Access Compliance Report

Public Rights-of-Way

(Curb Ramps)

Intersection ID: 50600	Main Street: BENDING_BRANCH_RD	Cross Street: HEARTLEAF_RD	Location: SE
ADA ID: 0733CD9AFC4A	Ramp Type: Perp	Initial Pass/Fail: Fail	Overall Compliance: No
Severity Score: 22.5			
Codes/Mitigation Info/Possible Solution		Field Measurements/Component Compliance

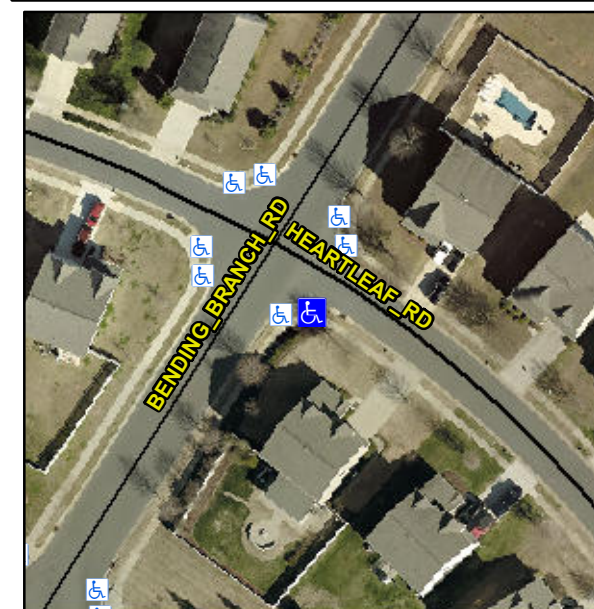
Not Found, R304.5.1, R304.2.2, R304.5.3

Compliance	Description	Data	Compliance	Description	Data
N/A	Ramp Length (in)	47.0	No	Ramp Slope (%)	9.9
No	Ramp Width (in)	47.5	No	Ramp XSlope (%)	5.0
N/A	Flare Type LT	N/A	N/A	Flare Type RT	N/A
N/A	Flare Slope LT (%)	N/A	N/A	Flare Slope RT (%)	N/A
N/A	Flare Traversable LT?	N/A	N/A	Flare Traversable RT?	N/A
N/A	Landing Length (in)	N/A	N/A	DWS Provided?	N/A
N/A	Landing Width (in)	N/A	N/A	DWS Contrast?	N/A
N/A	Landing Slope (%)	N/A	N/A	DWS Length (in)	N/A
N/A	Landing X Slope (%)	N/A	N/A	DWS Full Width?	N/A
N/A	Landing Curb? (Y/N)	N/A	N/A	DWS Offset (in)	N/A
N/A	Shared Landing?	N/A			
N/A	Gutter Ponding?	N/A	N/A	Gutter Slope (%)	N/A
N/A	Gutter Lip Ht (in)	N/A	N/A	Gutter X Slope (%)	N/A
N/A	Painted X Walk1?	No	N/A	Painted X Walk2?	N/A
	X Walk 1 Direction	To NE		X Walk 2 Direction	N/A
N/A	X Walk 1 Width (in)	N/A	N/A	X Walk 2 Width (in)	N/A
	X Walk 1 Slope (%)	1.9		X Walk 2 Slope (%)	N/A
	X Walk 1 X Slope (%)	3.9		X Walk 2 X Slope (%)	N/A

Remove & Replace Entire Ramp.
